Name: Gerhard Botha
Cell: 084 207 3454
E-mail: gerhard@nkurenkuru.co.za
Date: 14 April 2022
Ref: Lichtenburg 2 PV Part 2 Amendment

ECOLOGICAL AND AQUATIC/WETLAND COMMENTS: PROPOSED AMENDMENT TO THE AUTHORISED ABO WIND LICHTENBURG 2 PV PROJECT (DEA REF 14/12/16/3/3/2/1092).

Figure 2: Google Image™ illustrating the proposed amendment (extension) to the authorised grid corridor as well as the slightly smaller on-site substation footprint (now only 900m²).

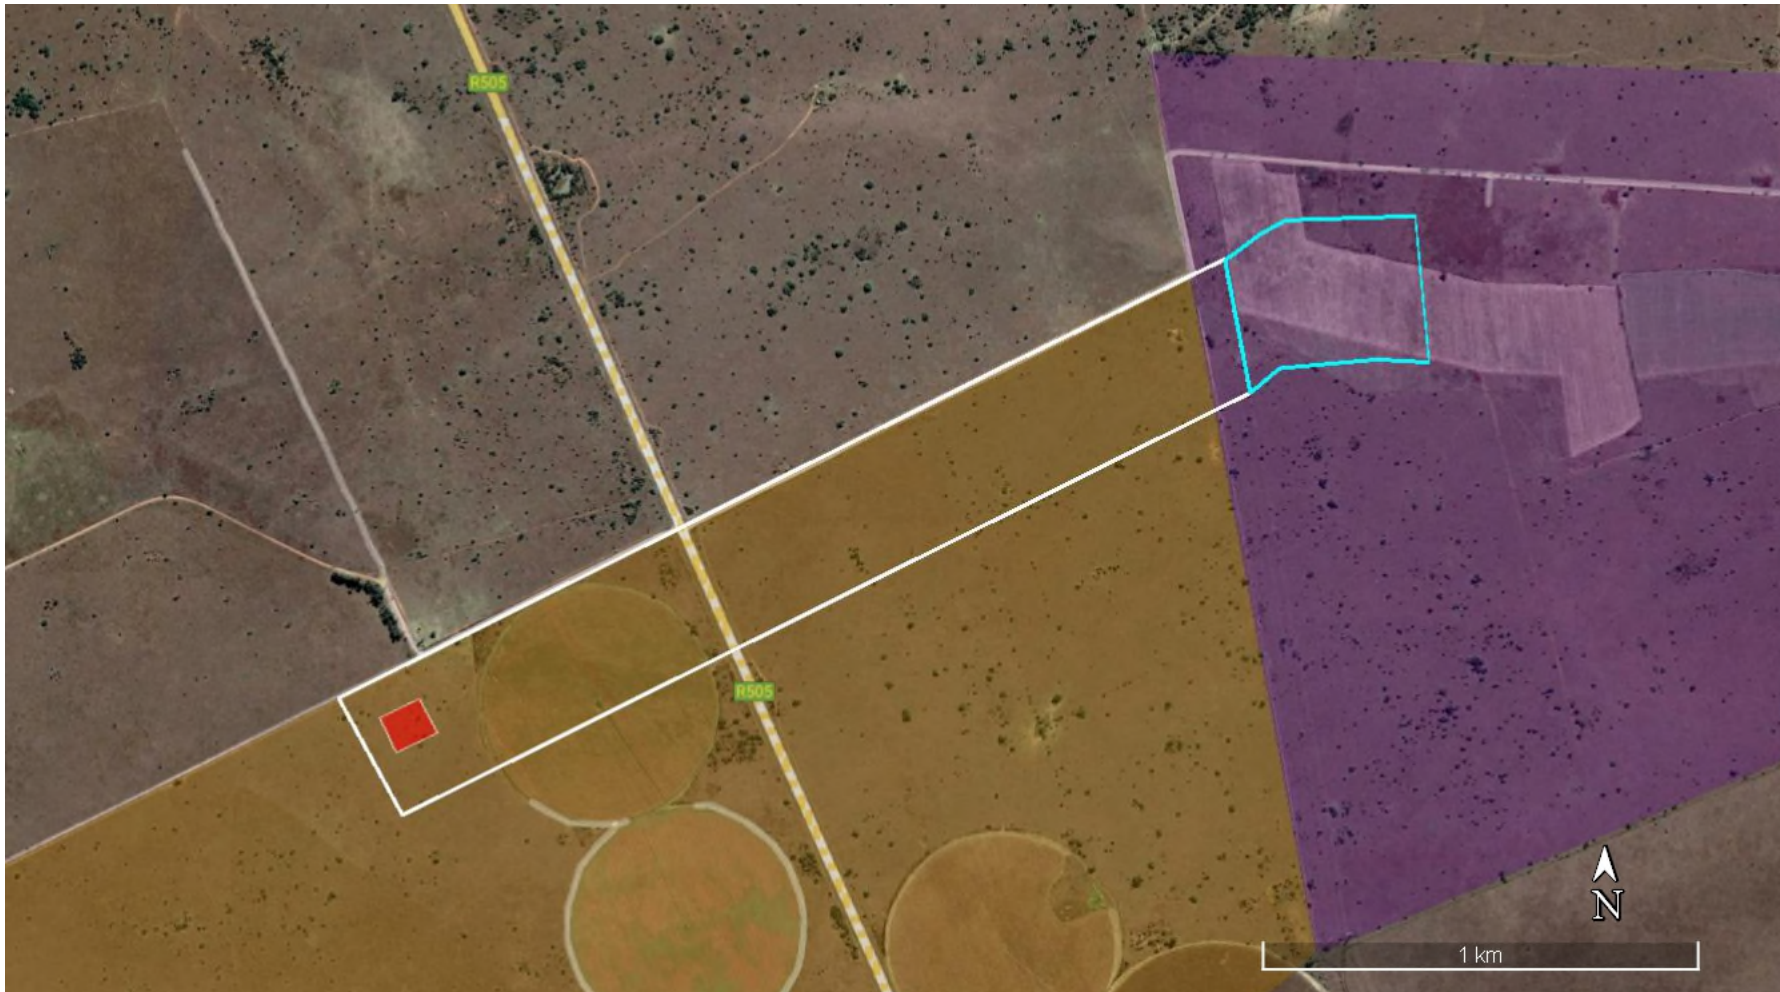
ABO Wind Lichtenburg 2 PV (Pty) Ltd is now considering the following amendments (Figure 2):

- » a change in the capacity of the step-up/on-site substation from 88/132kV to 33/132kV;
- » an extension to the authorised Loop-in/Loop-out (LILO) grid connection corridor, within an assessed area to allow Lichtenburg 2 PV to connect to the collector substation on Lichtenburg 3 PVs authorized property/footprint; and

- » Even though, the newly proposed, preferred grid route will be slightly longer, the extent of the additional area as well as the present ecological condition/status of this additional area is of such

a nature (small additional area, traversing mainly transformed areas), that a change in the significance of all assessed impacts is not warranted

- » The same situation is applicable for the amendment to the on-site substation, where the amendment to the development footprint (slight reduction), is not significant enough to warrant any change in the significance of all assessed impacts.
- » Furthermore, the proposed amendments to the preferred grid corridor and the on-site substation footprint will not result in any additional impacts (impacts not mentioned or assessed within the "original" ecological impact assessment).
- » Subsequently the assessment of the impacts within the original report will remain unchanged and are still applicable.

Figure 3: Google Images™ comparing how land use practices and the ecological status may have changed over time (between 2018 and 2021). From the satellite images it is clear that now significant changes have occurred over time.

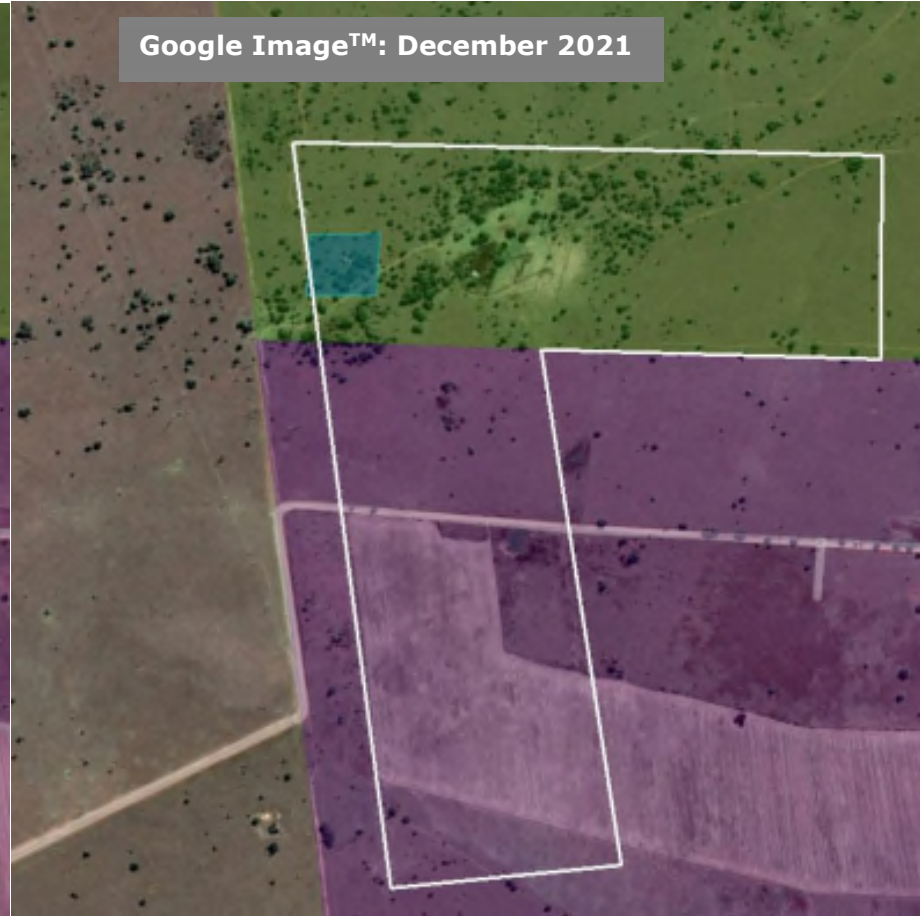
Based on a comparison between recent satellite images (Google Earth Satellite Image from December 2021) and satellite images used during the Ecological Assessment (Google Earth Image from May 2018), land use practices remained the same (predominantly cattle grazing with some areas being ploughed and cultivated) with no clear change in vegetation structure and the present ecological status of the assessed area (Figure 3). As such the need for a site visit as part of the Part 2 Amendment was deemed unnecessary with the findings of the terrestrial and wetland/ecological study and assessment still regarded as applicable.

Figure 4: Maps indicating the land coverages and land uses characterizing the newly proposed grid corridor and on-site substation.

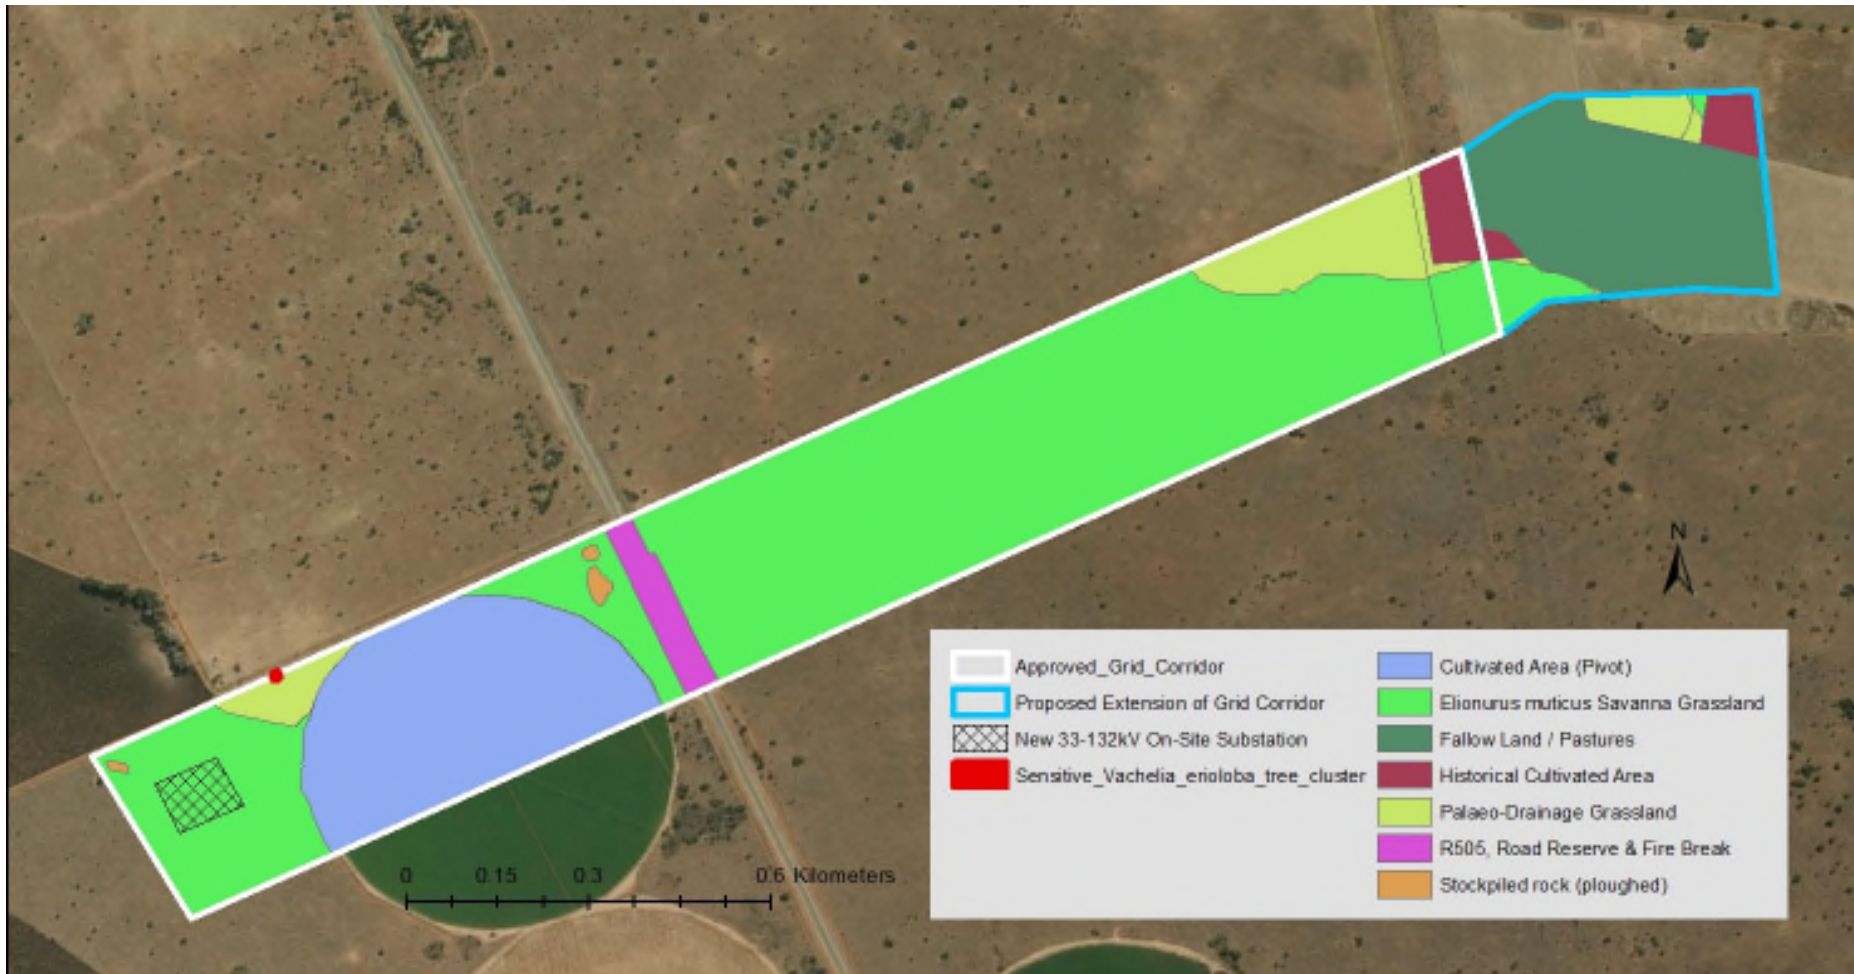
During the original ecological survey two vegetation associations were identified within the proposed grid corridors (Figure 4):

Plant association 2 covers slightly deeper sand-loam soils which are regarded as high to moderately high arable lands and as such large portions of this association have been extensively ploughed. Almost the entire portion of the proposed grid corridor extension area will be located within such transformed/ploughed areas that was historically covered by plant association 2. The bulk of the area is, however, covered by plant association 1 which covers shallow, rocky soil forms (as described within the Ecological Assessment/Report the bulk of the authorised grid corridor will be located within this plant association). Furthermore, other forms of disturbances/land use within the grid corridors include pivot irrigated areas, kraals, the R505 Road and numerous dirt roads (twin tracks).

As mentioned, the authorised grid corridor and on-site substation will be almost entirely located within plant association 1 whilst the newly proposed grid corridor will be mostly located within plant association 2 (of which most have been transformed through cultivation practices).

According to the sensitivity assessment, both of these vegetation associations have been classified as **medium sensitivity** (Figure 5). All disturbed and transformed areas have been furthermore, classified as **low sensitivity**. During the Ecological Study and Assessment, it was found that both of these vegetation associates were regarded as **acceptable for the proposed grid infrastructure development**.
